HORSHAM DISTRICT COUNCIL CONSULTATION

TO:	Horsham District Council – Planning Dept
LOCATION:	Land to the South of Broadbridge Way Broadbridge Heath
DESCRIPTION:	Full Planning Application for the erection of 89no. residential dwellings comprising dwellings (54no.) and apartments (35no.), 36% affordable homes, creation of new vehicular access on to Sergent Way, provision of public open space, landscaping and drainage solutions
REFERENCE:	DC/25/0894
RECOMMENDATION:	Holding objection / modification
RECOMMENDATION: 2nd Response in Red	Objection maintained, as modification is still needed to address Root Protection Area conflicts and concerns.
RECOMMENDATION: 3rd response in green	Advice / Holding objection withdrawn
RECOMMENDATION: 4th response in orange	Advice
SUMMARY OF COMMENTS & RECOMMENDATION: The submitted Arboricultural method statement and Tree protection plan are a fair assessment of the tree-related impacts of the development proposals at the site. However, some modification to the site layout is needed to address Root Protection Area conflicts and likely future resident pressure due to poor tree-to-build relationships post-development.

PROPOSED SITE LAYOUT showing the carpark to the north of T31 & T19

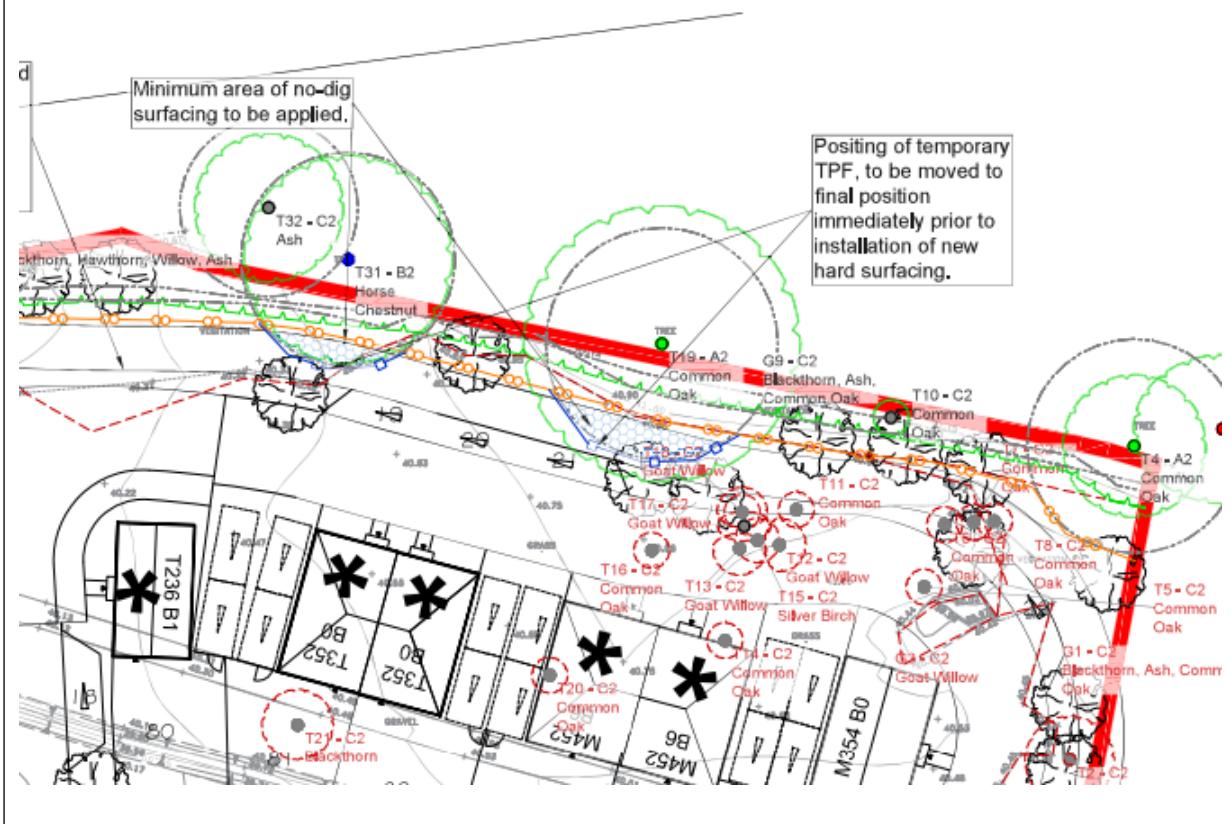
The Root Protection Areas (RPAs) for trees T31, T19, and T34 are still not considered to be plotted in accordance with BS5837:2012 (Section 4.6.2). whereby, existing off-site hardstanding within the northern portions of the RPAs of T31 and T19, and to the east of T34 where the RPA extends beneath Old Whickhurst Lane, has not been considered, offset, or modified to reflect the likely asymmetric rooting environment created by these constraints.

BS5837:2012 requires that where existing obstacles or surfaces constrain root development, the RPA should be amended to show where roots are most likely to occur. In this case, the off-site car park to the north of T31 and T19, which is clearly visible on the indicative site plan, has been omitted from the Tree Protection Plan. This results in a misleading representation of the trees' functional rooting environment and raises concern as to why this constraint has not been factored into the arboricultural assessment, particularly as it was raised in my previous response.

For both T31 and T19, nearly half of the theoretical RPA is currently shown extending beneath an impermeable car park surface to the north. This means that any additional encroachment into the remaining functional (southern) portion of the RPA becomes significantly more critical. As such, based on the current assessment the proposed cycle path, to the south of the trees, in particular, would in my opinion, increase development within the RPA as is currently shown well beyond the 20% threshold generally accepted within BS5837, further exacerbating non-compliance with the BS.

Tree Protection Plan DWG NO: VYH24657-03A Sheet 2 of 2. It should be noted that the date on the new TPP has not been updated from the 17/04/2025 submission, despite the plans and site layout having been altered.

Given the likely southward rooting bias for T31 and T19, caused by the existing hardstanding, the proposed new road to the south is expected to lie partially or wholly within the functional RPAs of T31 and T34. No mitigation measures have been proposed to address this conflict. As such, the scheme is not considered to be compliant with BS5837 and is likely to result in significant, delayed-onset harm to these trees over the next 5-10 years, due to construction activity and root loss/damage within their key rooting areas, unless the layout is amended accordingly.
